Name: FL D.O.T. (S.R. 60 & Reedy Creek Bridge Replacement)

SURFACE WATER MANAGEMENT PERMIT NO. 49-00765-S

PROJECT: SR 600 RELOCATION & REEDY CREEK BRIDGE REPLACEMENT
APPLICATION NUMBER: 960124-5
PERMIT MODIFICATION NUMBER: 49-00765-S

Re: Reconstruction of State Road 600/U.S. 17/92 at Reedy Creek
Response to Third RAI, ERP Application
SFWMD Conceptual Permit # 49-00765-S, Dated 11/10/94
FDOT Project # 92010-3520
Page 1 of 2

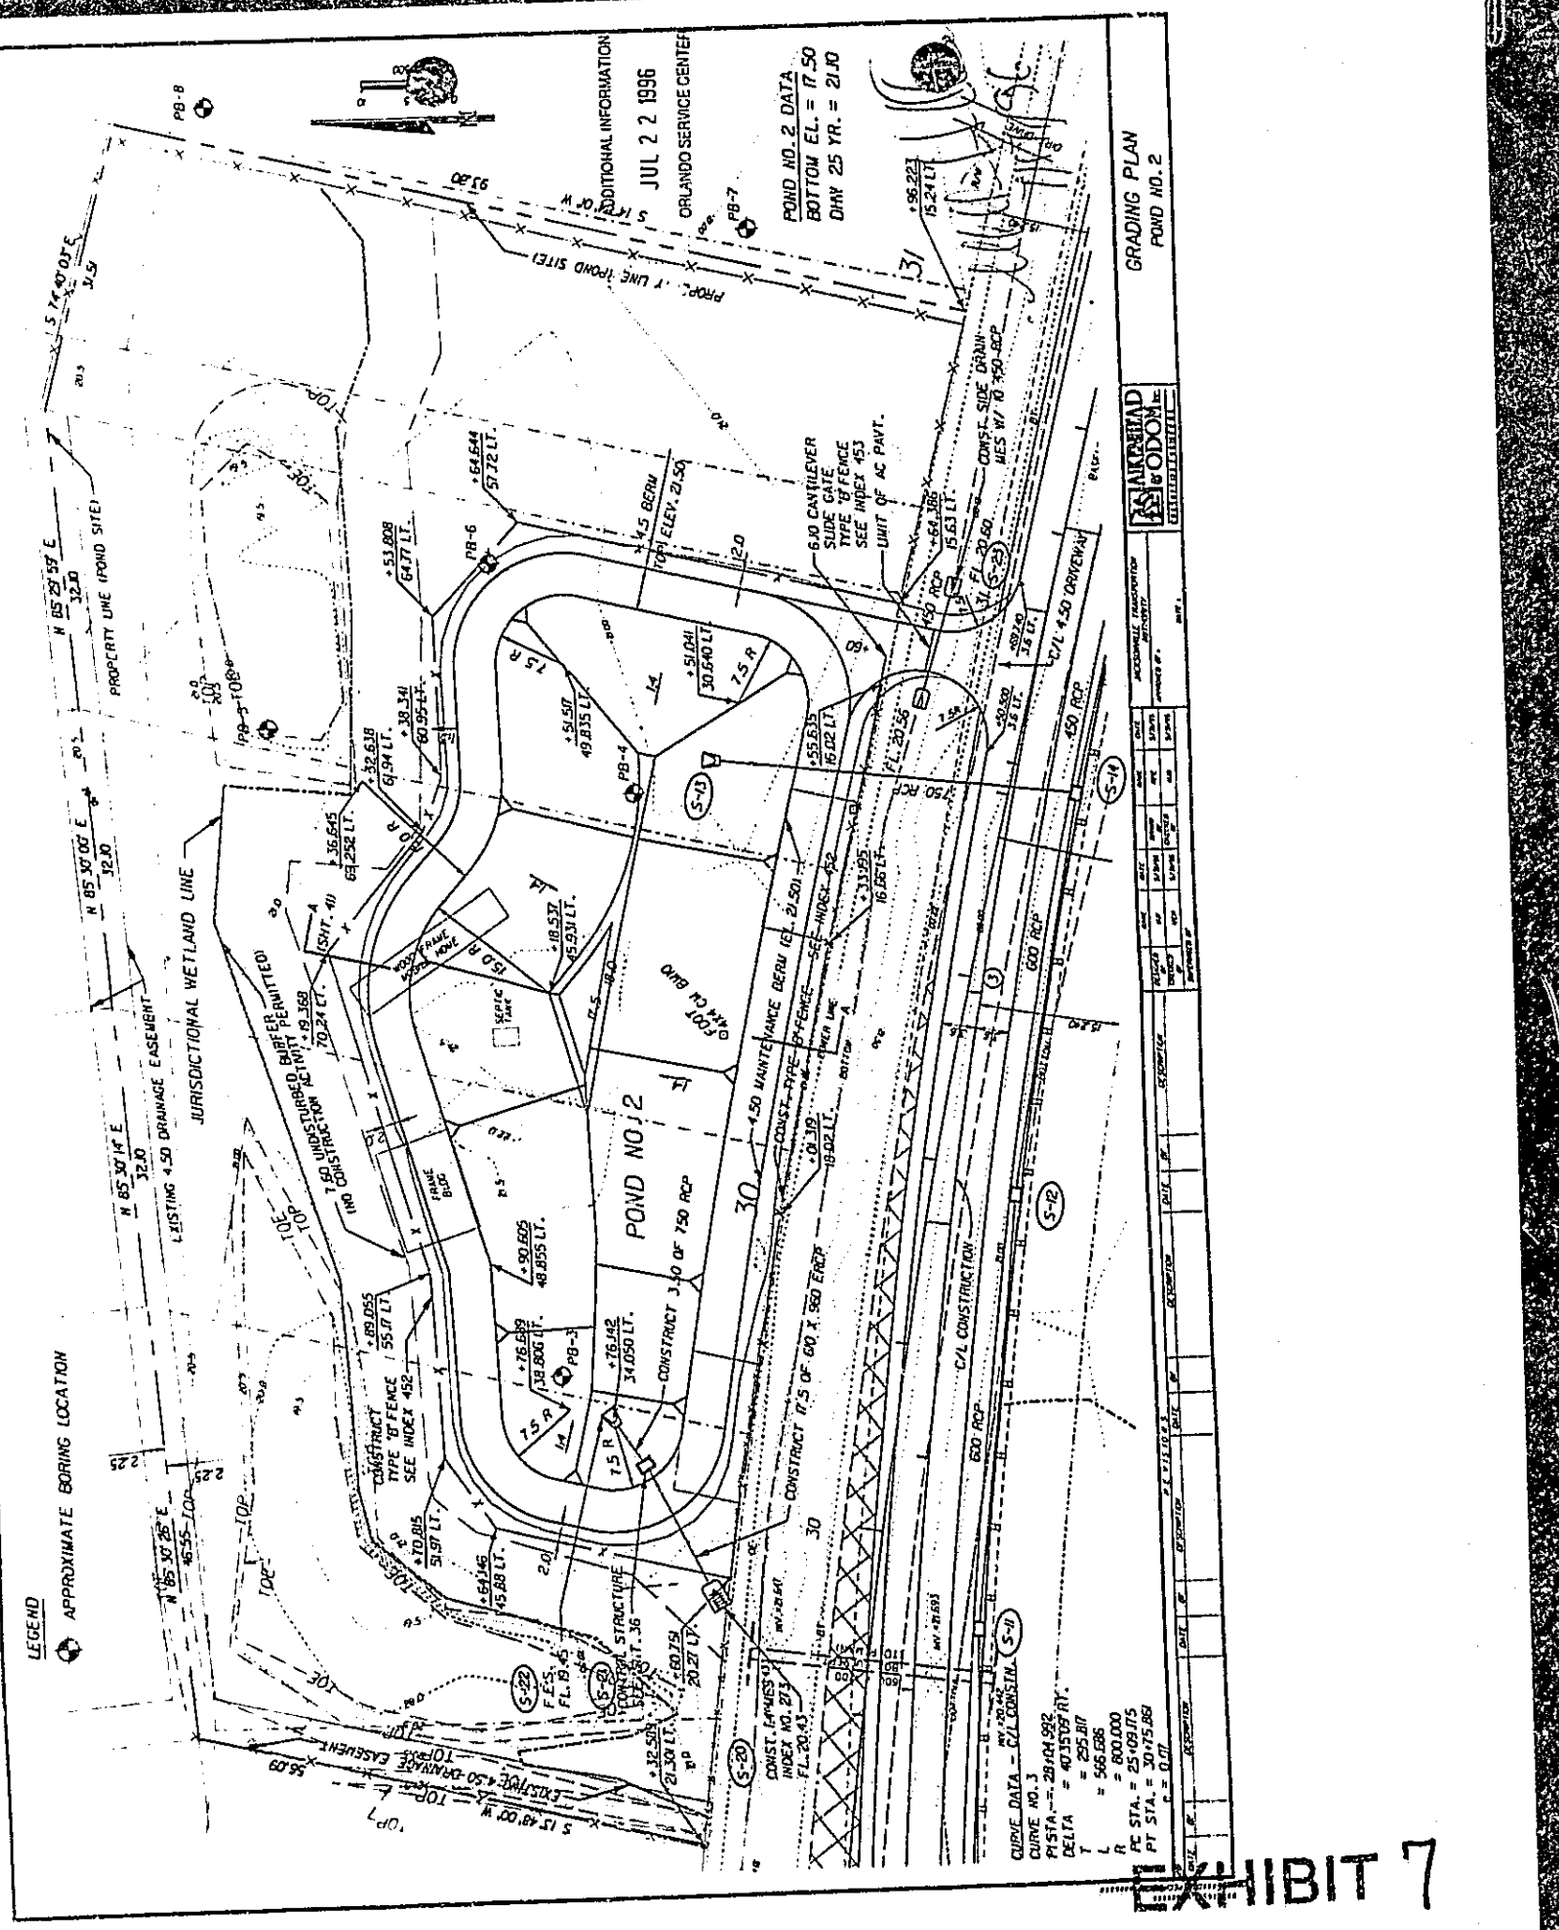
Sheet 40 - Grading Plan - Pond No. 2:

- The wetland impact areas have been identified with hatching.
- The limit of construction in the wetland area has been identified.
- Turbidity and erosion control devices have been added and identified.

PROJECT NUMBER	SHEET NO.
9200-3520	98

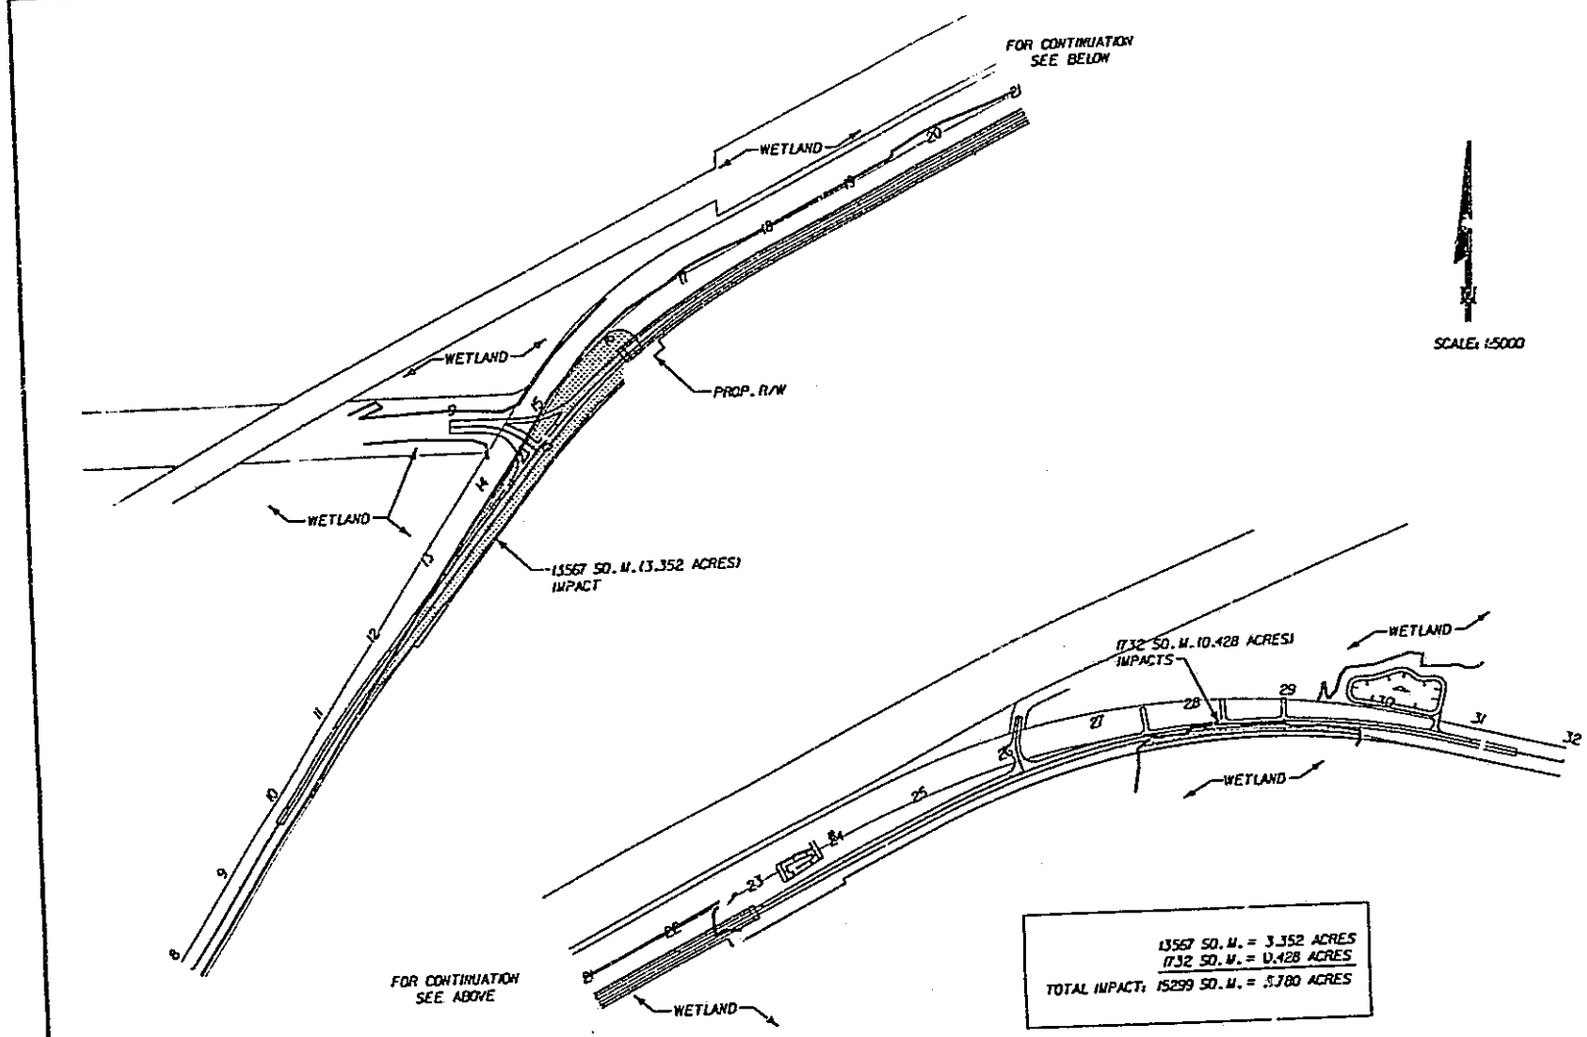
(a) Please revise the Plan & Profile and Sheet 98 portions of the construction plans to illustrate and label the impacts associated with the bridge (including the area of clearing). Please revise Sheet 98 to include an acreage figure in the label; and

2. There appears to be inconsistencies between Sheet 98 and the Plan and Profile portions of the construction plans. Please revise the Plan and Profile sheets to reflect the following information (as depicted on Sheet 98):

Sheet 98 - Wetland Impacts:

- The impacts associated with the bridge have been hatched, labeled, and the quantity added to the label.

PROJECT NUMBER 92010-3520
SHEET NO. 38
PHONE LINE
POWER LINE
SEWER LINE
POWER POLE
BASELINE SURVEY
B SURVEY
EXISTING PAVT. TO REMAIN
CONTROL STRUCTURE SEE DETAIL - SHEET 39
CONST. 2.5 OF 600 RCP
CONC. SPILLWAY SEE DETAIL SHT. 39
+40.000

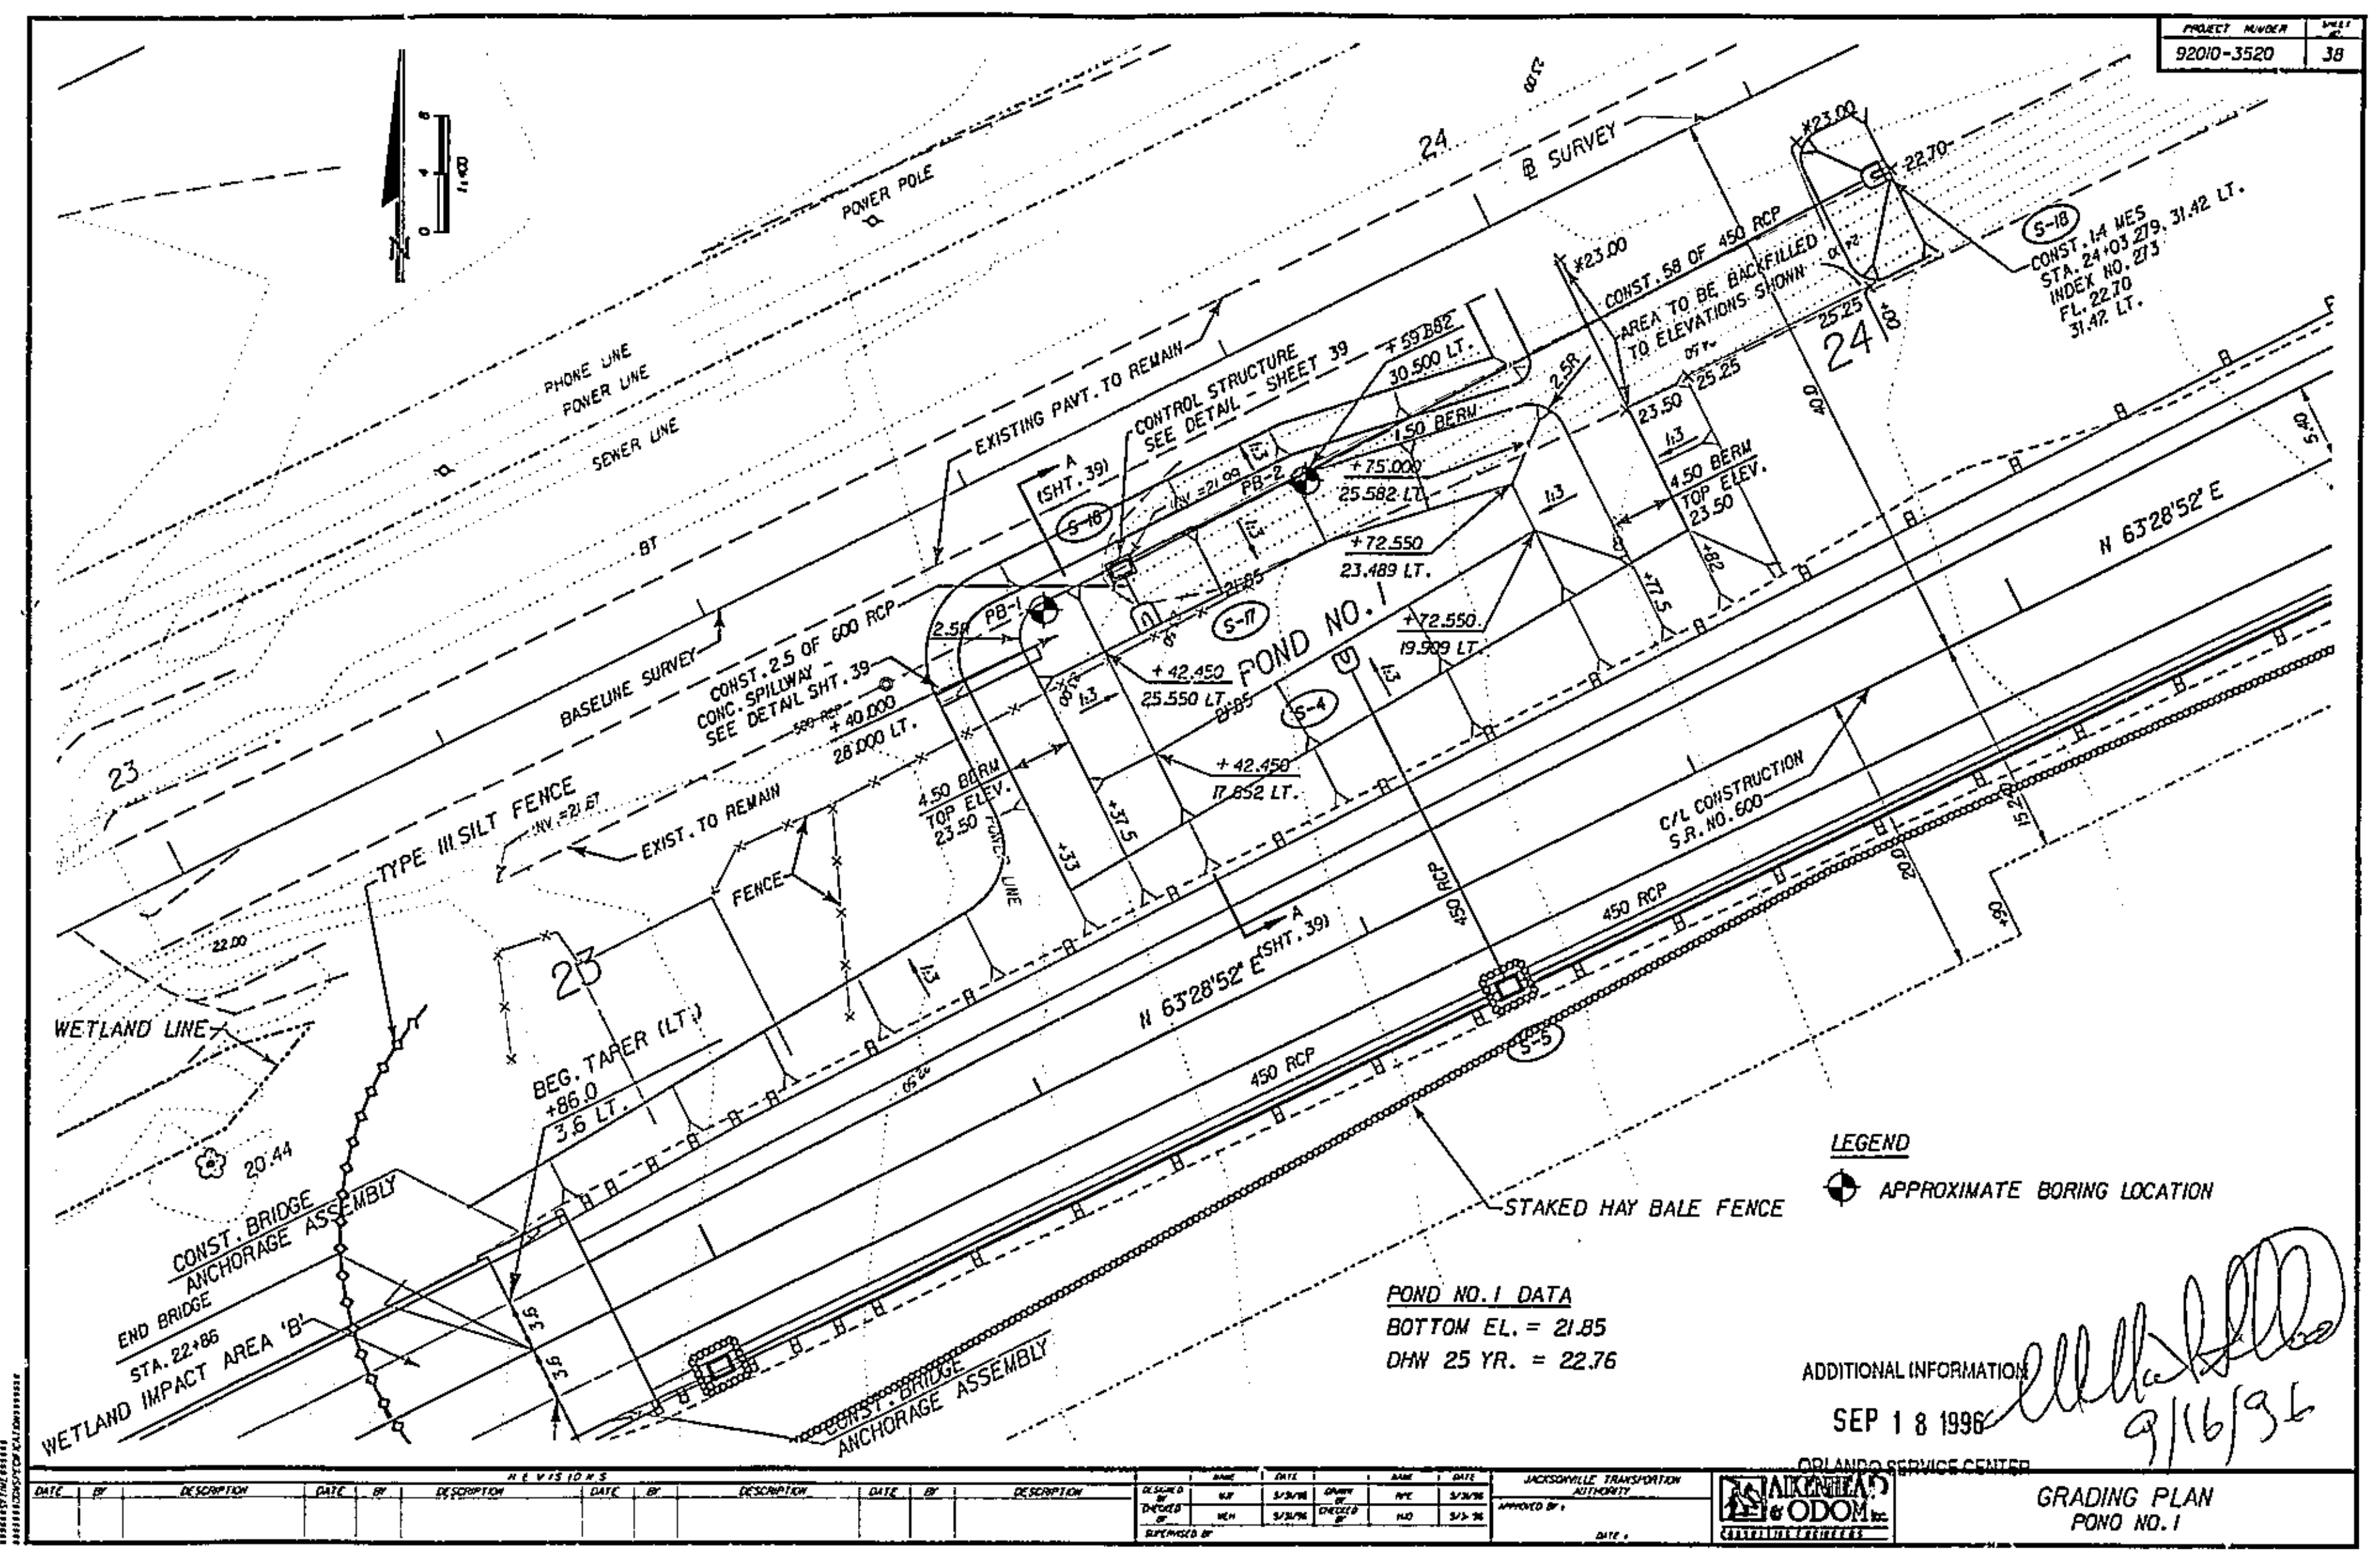
Sheet 38 - Grading Plan - Pond No. 1:

- The wetland impact areas have been identified with hatching.
- Turbidity and erosion control devices have been added and identified.
